PLANNING COMMISSION STAFF REPORT

MEETING DATE: February 8, 2022

AGENDA ITEM TITLE: 1. A. Residences at Salida Bottling Company Planned Development; and
1. B. Residences at Salida Bottling Company Major Subdivision

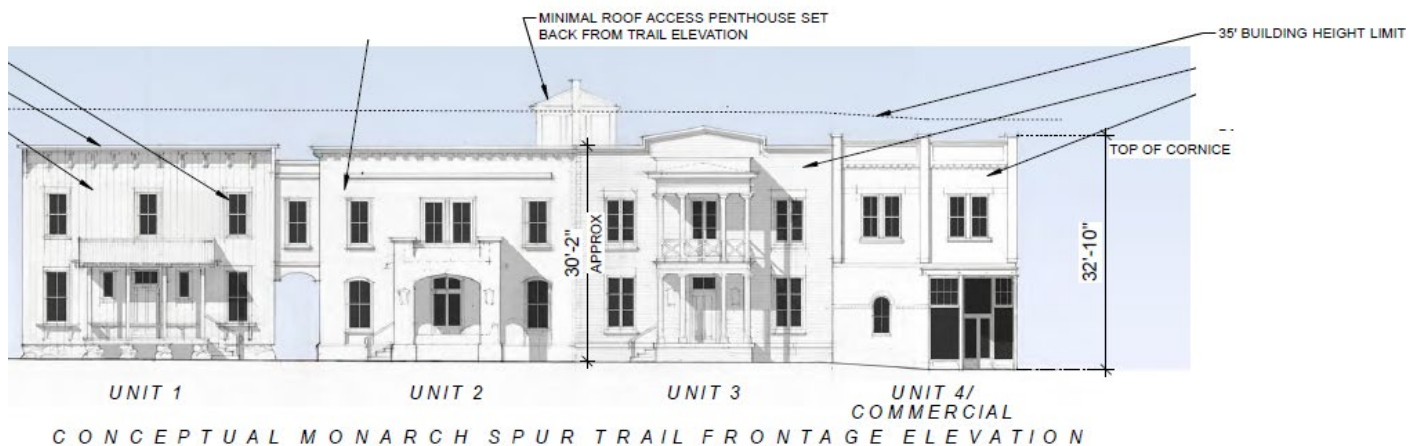
Units 1-4 (illustrated below and in yellow on the site plan). Units 1-4 are proposed at the allowed 2 stories for the majority of the structures. A deviation is requested for the portions of Units 1-4 shown in yellow on page 8, in which the applicant is requesting the ability to locate a rooftop access structure, limited to 100 sf per unit, with a maximum height of 40 feet to the highest point of the structure.

Staff recommends that the request be limited to the minimum necessary to allow rooftop access and only where it will not potentially obstruct prominent view corridors from downtown. Therefore staff recommends that rooftop access on Units 2 & 3 be allowed only as one combined structure at a total of 100 sf for the two units, and recommends that no rooftop access structure be allowed on Unit 4 due to the higher visibility of that location from downtown and the potential obstruction of prominent viewsheds. Unit 1 would be limited to a single, 100 sf maximum, rooftop access structure. The recommended condition of approval is:

- Units 1-3 are allowed a rooftop access structure that cannot exceed 40 feet in height at its highest point. It may be up to 100 square feet on Unit 1. Units 2 & 3 are allowed a shared rooftop access structure up to 150 square feet (in total, not per unit). Shared structure can be greater than 150 square feet only if required by the Building Official, and shall be limited to the minimum required square footage. No rooftop access structure is allowed on Unit 4; this does not prohibit access to the roof.

Concept of Unit 6 illustrating a portion at 2.5 story and a portion at 3 story

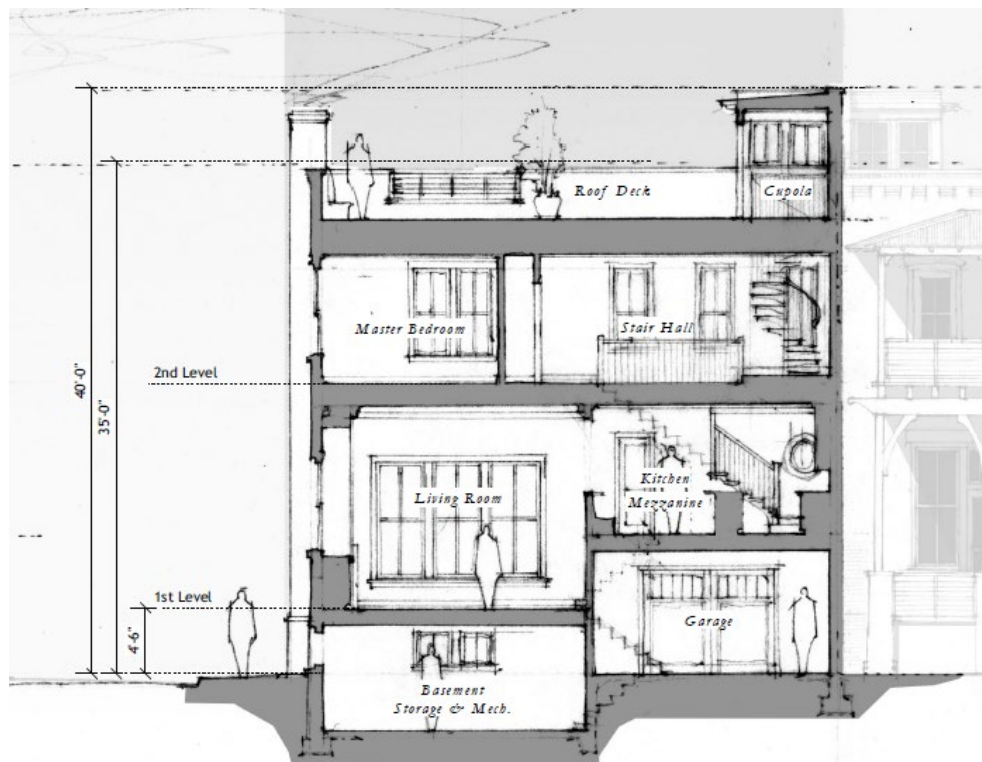
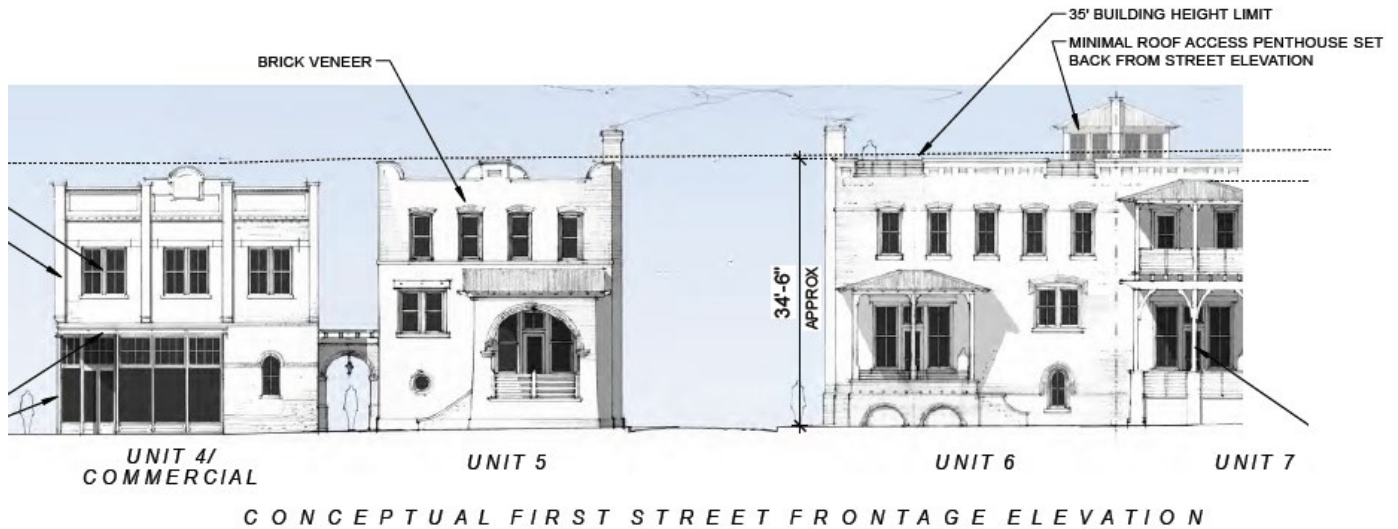
Units 5-7 (illustrated below and in blue on the site plan). The applicant is requesting a deviation to allow Units 5-7 to be 3 story buildings. The proposed maximum height of the 3 stories is 35 feet, which does not require a deviation. However, a deviation is requested to allow a rooftop access structure, limited to 100 sf per unit, to be a maximum of 40 feet at its highest point. Additionally, the applicant has requested an allowance for chimneys up to 40 feet.

The request for 3 stories along 1st Street will allow for the accommodation of the proposed historically relevant architectural design that is unique for new construction. It is a design that, when viewing from 1st & F Street, reads as an extension of the historic downtown. The primary structure will be a maximum of 35 feet in height, which is allowed in the Overlay District. Therefore staff supports the request for 3 stories. Staff recommends that the rooftop access request be limited to the minimum necessary and only where it will not potentially obstruct prominent view corridors from downtown. For this reason, staff recommends that no rooftop access structure be allowed on Unit 5 and that rooftop access on Units 6 & 7 be allowed only as one combined structure at a total of 100 sf. The recommended condition of approval is:

- Units 5-7 can be a maximum of 3 stories and 35 feet in height with the exception of chimneys and a rooftop access structure on Units 6 & 7. Units 6 & 7 are allowed a shared

rooftop access structure that cannot exceed 40 feet in height at its highest point, and can be up to 150 square feet (in total, not per unit). Shared structure can be greater than 150 square feet only if required by the Building Official, and shall be limited to the minimum required square footage. No rooftop access structure is allowed on Unit 5; **this does not prohibit access to the roof**. Chimneys shall not exceed 40 feet.

Example of rooftop decks on the gabled roof portion of the site, potentially Units 8-16.

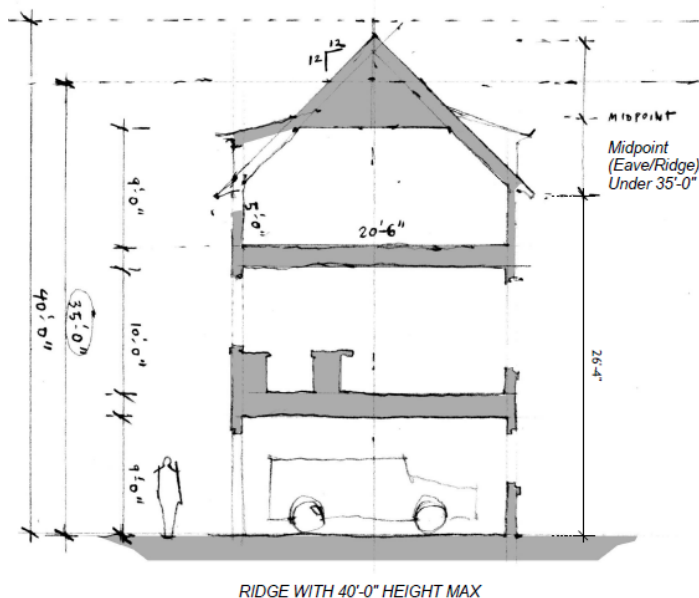
Units 8 -16 (building section below, and shown in green on page 8). The applicant has requested a deviation to Units 8-16 to be 3 stories, and a deviation to allow 40 feet in height. As shown in the illustration below, the allowance for 40 feet would be to accommodate the peak of the gabled roof. These units do not front Hwy 291, are separated from the property to the south by an alley, and are adjacent to a gas station to the west. Staff supports the request for 3 stories off of Hwy 291. If the building height deviation to 40 feet is approved, staff recommends conditioning it to only accommodate a gabled roof and not a flat roof.

The conceptual rendering below shows potential rooftop decks on this portion of the site. Specific details were not provided for these decks. Staff recommends that no portion of the deck (including railings, shade structures, etc) shall exceed 35 feet in height. This condition will ensure that a person standing on the deck will not be visible above a 40-foot peaked roof.

- Units 8-16 can be a maximum of 3 stories. They can be a maximum of 40 feet in height only to accommodate the peak of a gabled roof. **If a flat roof with parapet is proposed, building height, including parapets, cannot exceed 35 feet.** No part of a rooftop deck, including railings or covers, can exceed 35 feet.

VIEW CORRIDOR STUDY: View from 1st Street, just west of F Street

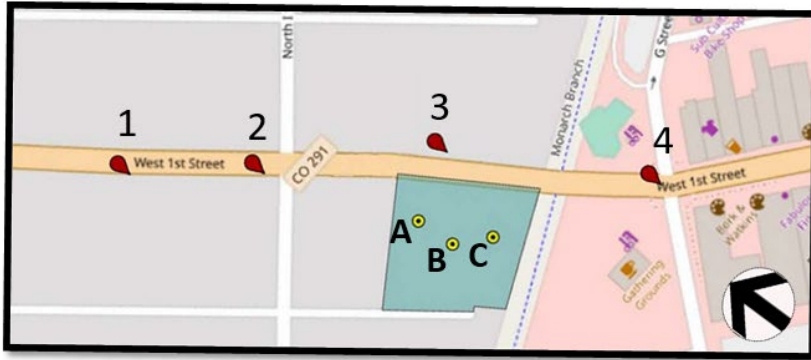
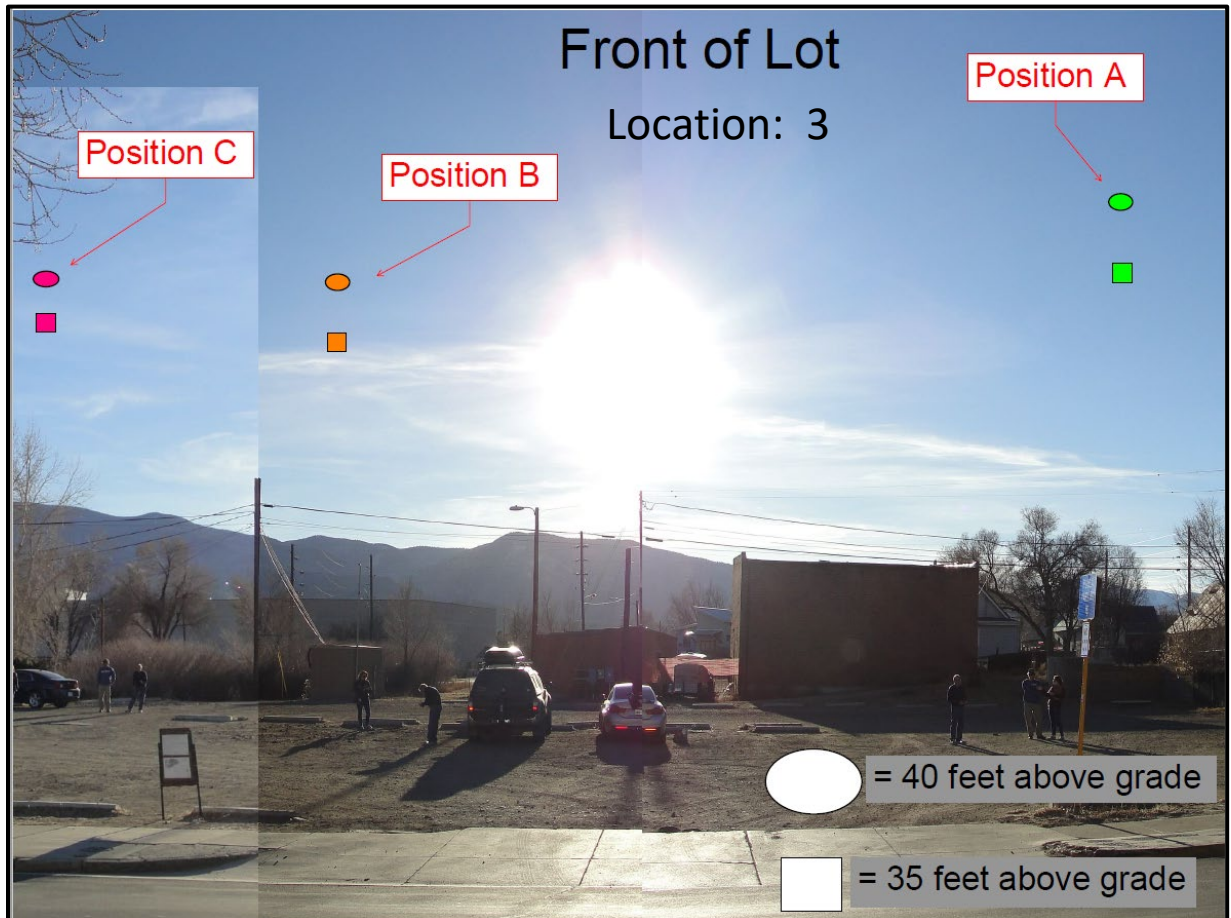
To determine the impact of the request on views of the Sawatch Range from the intersection of 1st and F Street, the applicant has provided a view corridor study. The corridor study illustrates that the development, and the requested height deviations, will be visible. However, being visible alone does not make the visual impacts “adverse”. From this vantage point, it does not interrupt the mountain vista. It provides visual continuity of the downtown architecture and urban density as it transitions to a more residential use.

EXHIBIT A. Additional height above current code allowance that would be granted if the deviation allowed measurement from finished floor elevation only – illustrated below: (only instances where the height exceeds 35' or 40' (based on prior request) are illustrated)

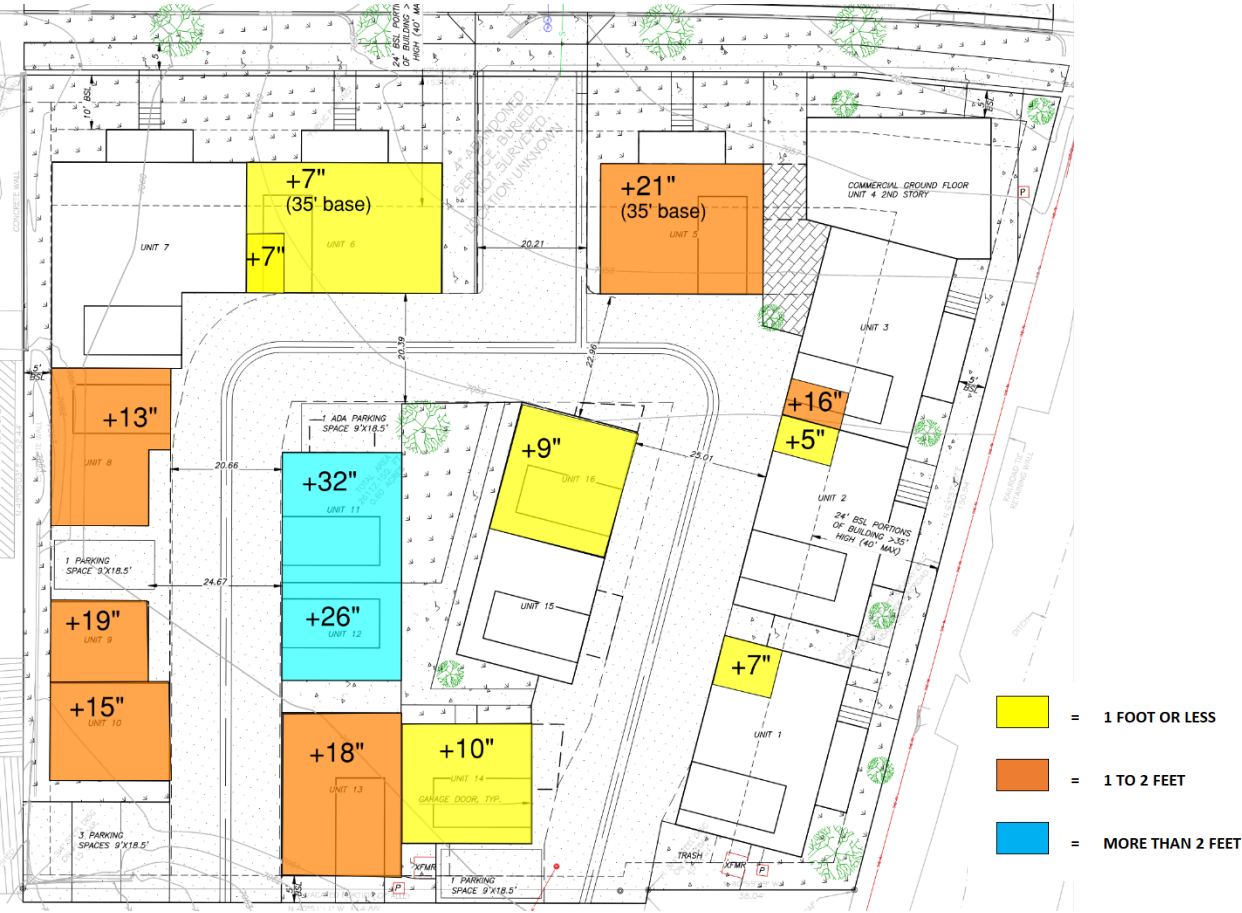
However, staff does not support a request to measure height solely from the finished floor (FF) elevation, which can vary greatly based on architectural plans and styles and are not necessarily contingent upon exterior conditions. Staff recommends that the building height measurement be taken from the lower of either the average post-construction grade or finished floor elevations. Examples of how the applicant's request, and how staff's recommendation, differentiate from the code requirement are illustrated below:

The effects of this option are significantly more in line with the code requirement while still allowing the applicant the practical ease of not having to account for pre-construction grades. The area that is impacted is the area that has the least visual impact on the view corridor from 1st Street and downtown.

The measurements that were provided by the applicant in the packet, and that staff utilized to calculate the measurements for the above analysis, were done on a building -by-building basis. To allow for a common roof line between attached units, there will be a balancing out across the connected units when the averages are based on the entirety of the building. If using the lower of the post-construction grade or finished floor, the result will not differentiate significantly than using those same averages at pre-construction grade.

- The measurement of building height shall use the lower base elevation of either the finished floor or the average post construction grade around building perimeter. On a multi-unit building with a singular roof line, the average of the entire perimeter shall be compared to the average of the finished floor elevations, and the lower average shall be used.
